Superfund 1st Five-Year Review Report
Smith's Farm Landfill
Brooks, Bullitt County, Kentucky

Prepared For:
U.S. Environmental Protection Agency, Region IV

Prepared By:
U.S. Army Corps of Engineers, Louisville District

September 2001

Figure 5
Gas Control System

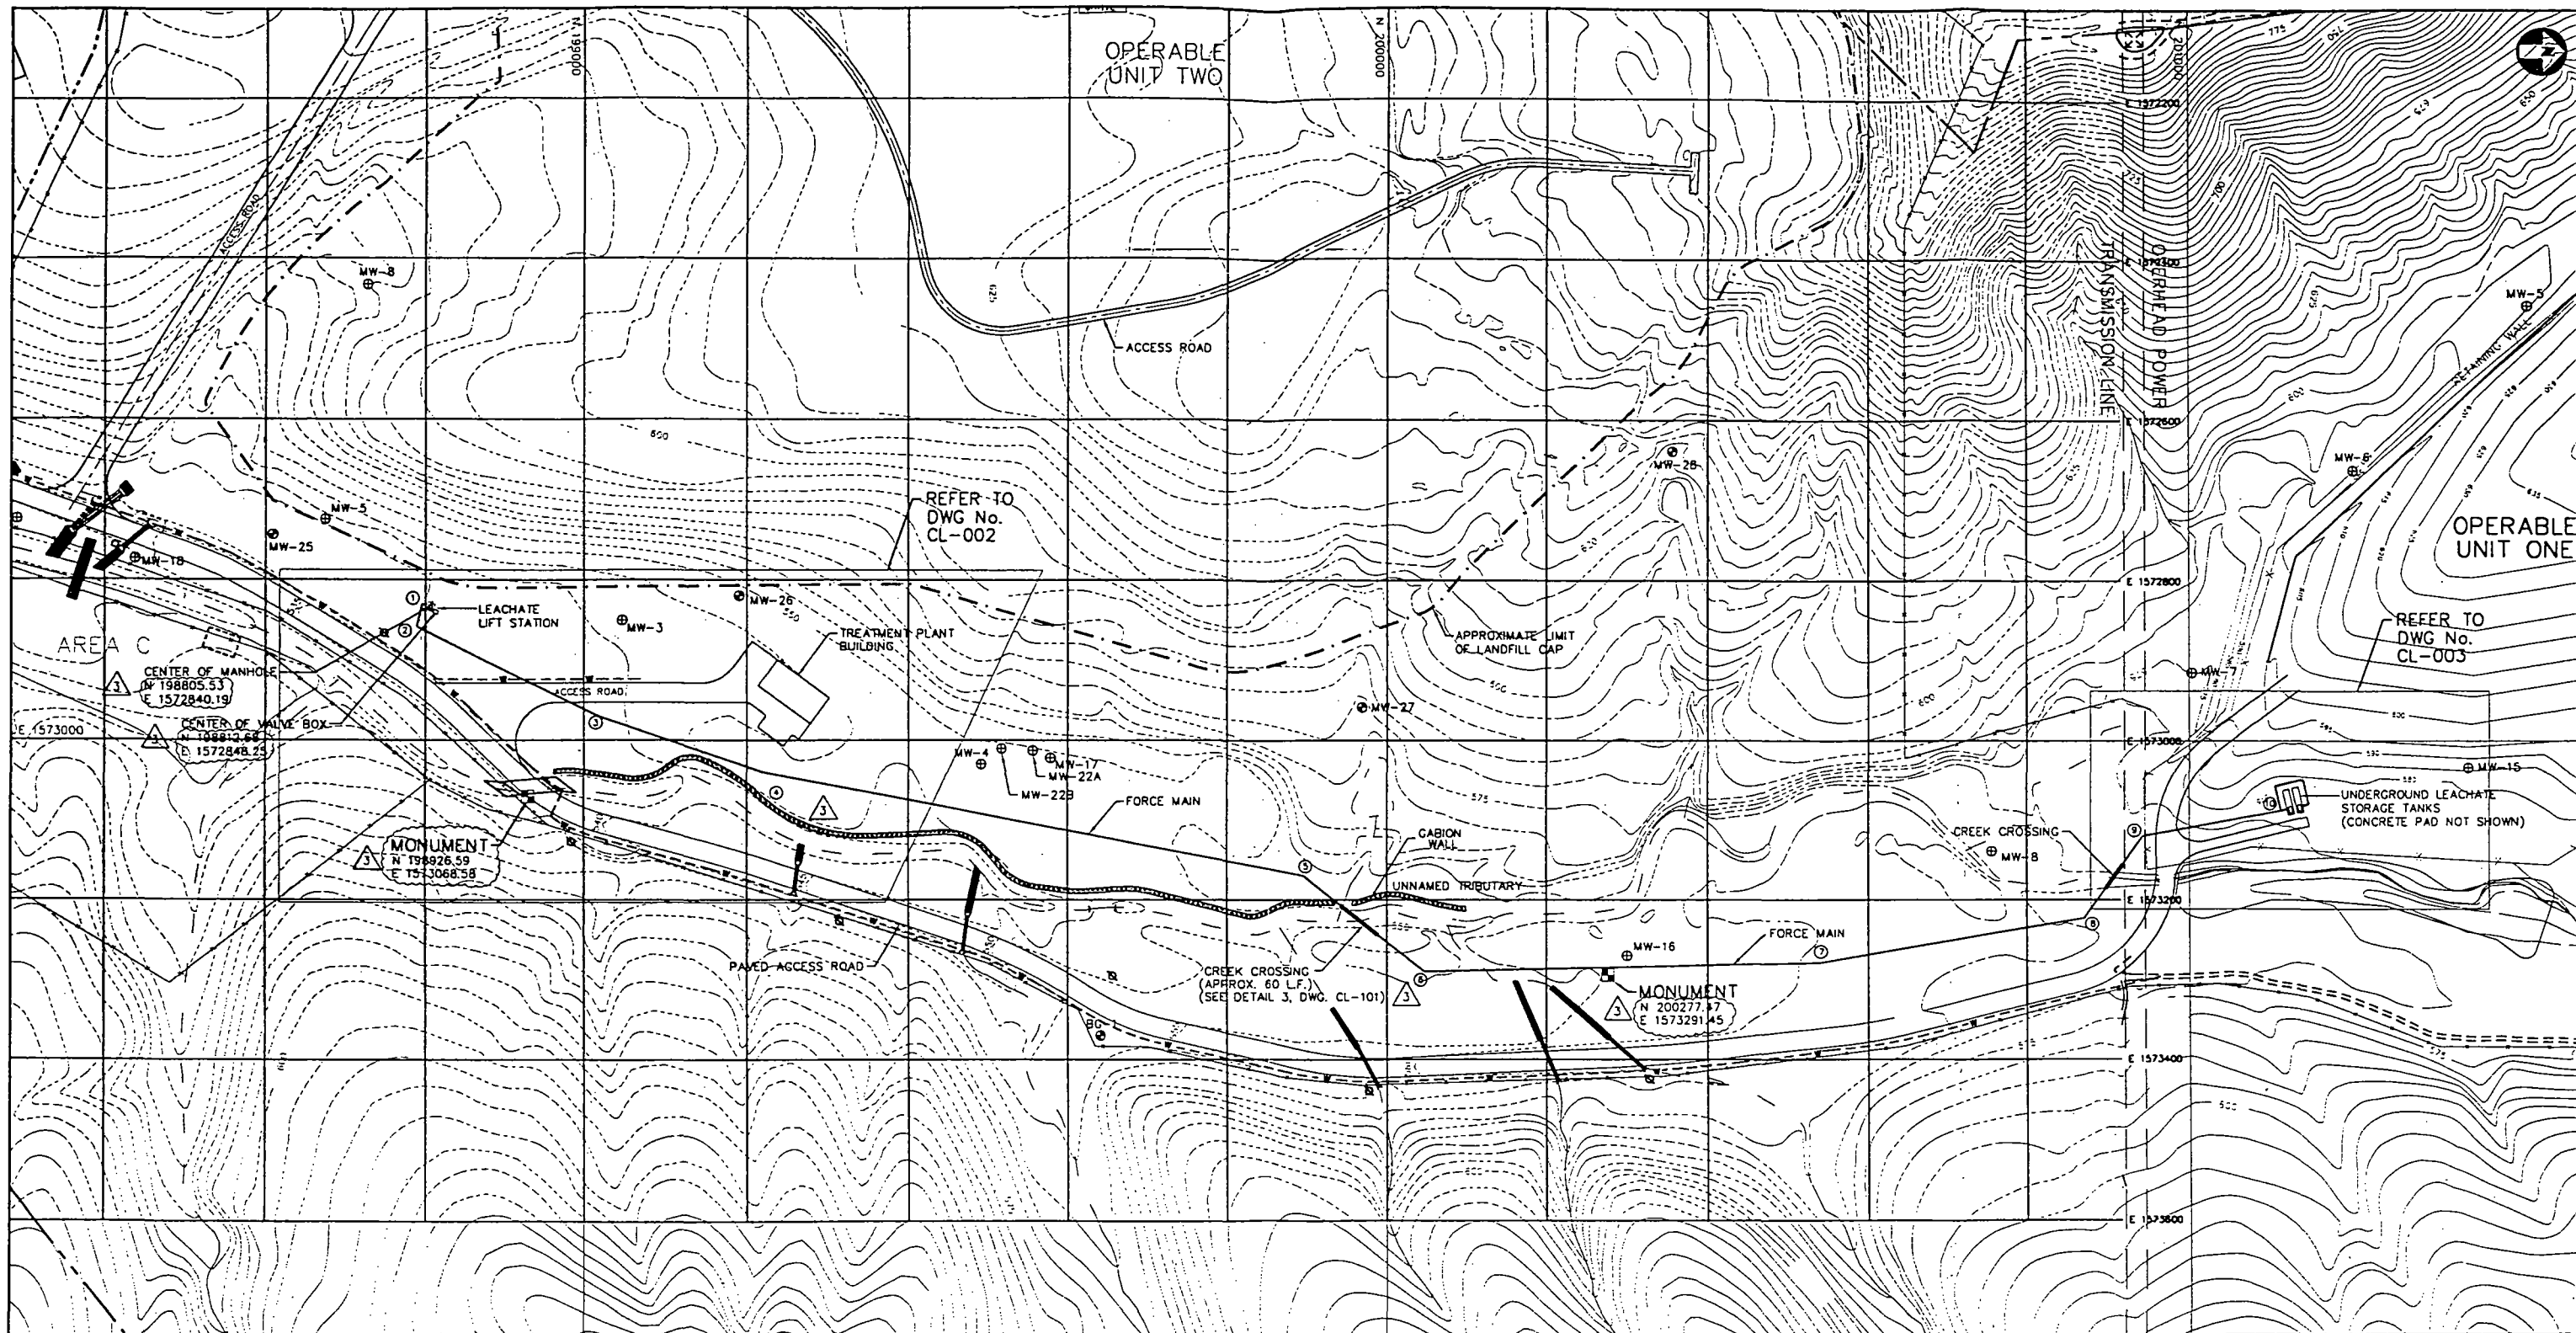
Remarks # SOME VENT PIPES WERE INSTALLED SUCH THAT THE PIPES LEANED.
REFER TO GAS CONTROL PLAN CL-010.

- Inspect gas vent pipes for damage or tilting. A gas vent well tilting down slope may be an indication of cover soil movement. Correct as appropriate.
